Access Compliance Report

Public Rights-of-Way (Curb Ramps)

Intersection ID: 42498	Main Street: ALEXANDER MARTIN AV	Cross Street: BLAKENEY GREENS BV	Location: SW
ADA ID: 24E7B984F145	Ramp Type: PerpDiag	Initial Pass/Fail: Fail	Overall Compliance: No
		Severity Score: 8.75

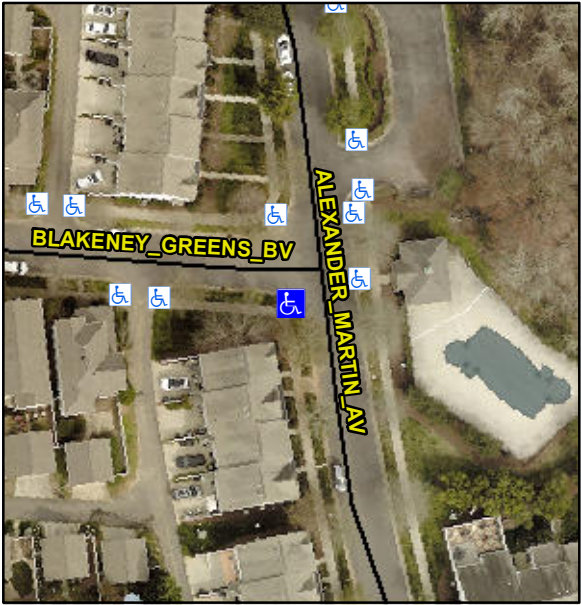
Codes/Mitigation Info/Possible Solution		Field Measurements/Component Compliance					
	Possible Solutions:	Compliance	Description	Data	Compliance	Description	Data
	Remove & Replace Curb Ramp With Two New Directional Ramps or Equivalent.	N/A	Ramp Length (in)	82.0	Yes	Ramp Slope (%)	6.2
		No	Ramp Width (in)	46.0	Yes	Ramp XSlope (%)	0.1
		N/A	Flare Type LT	N/A	N/A	Flare Type RT	N/A
		N/A	Flare Slope LT (%)	N/A	N/A	Flare Slope RT (%)	N/A
		N/A	Flare Traversable LT?	N/A	N/A	Flare Traversable RT?	N/A
		N/A	Landing Length (in)	N/A	N/A	DWS Provided?	N/A
		N/A	Landing Width (in)	N/A	N/A	DWS Contrast?	N/A
		N/A	Landing Slope (%)	N/A	N/A	DWS Length (in)	N/A
		N/A	Landing X Slope (%)	N/A	N/A	DWS Full Width?	N/A
		N/A	Landing Curb? (Y/N)	N/A	N/A	DWS Offset (in)	N/A
		N/A	Shared Landing?	N/A			
		N/A	Gutter Ponding?	N/A	N/A	Gutter Slope (%)	N/A
		N/A	Gutter Lip Ht (in)	N/A	N/A	Gutter X Slope (%)	N/A
		N/A	Painted X Walk1?	No	N/A	Painted X Walk2?	No

X Walk 1 Direction	To E		X Walk 2 Direction	To N
		N/A	X Walk 1 Width (in)	N/A	N/A	X Walk 2 Width (in)	N/A
			X Walk 1 Slope (%)	5.0		X Walk 2 Slope (%)	0.9
			X Walk 1 X Slope (%)	0.5		X Walk 2 X Slope (%)	0.1
		N/A	Ramp inside XWalk1?	N/A	N/A	Ramp inside XWalk2?	N/A
<p>Surveyor Notes:</p> <p>N/A</p> <p>PROW/ADA:</p> <p>Not Found, R304.5.1</p>			Road Slope (%)	0.3	N/A	Clear Space?	N/A
			Road X Slope (%)	1.1	N/A	Clear Space to XWalk (in)	N/A
		N/A	Any Obstructions?	N/A	N/A	Storm Grate/Utility Hazard?	N/A
			Obstruction Type			Storm Grate/Utility Type	
					N/A		N/A
					Yes	Surface Condition? (G/P)	Good
Total Cost:		\$	3200.00
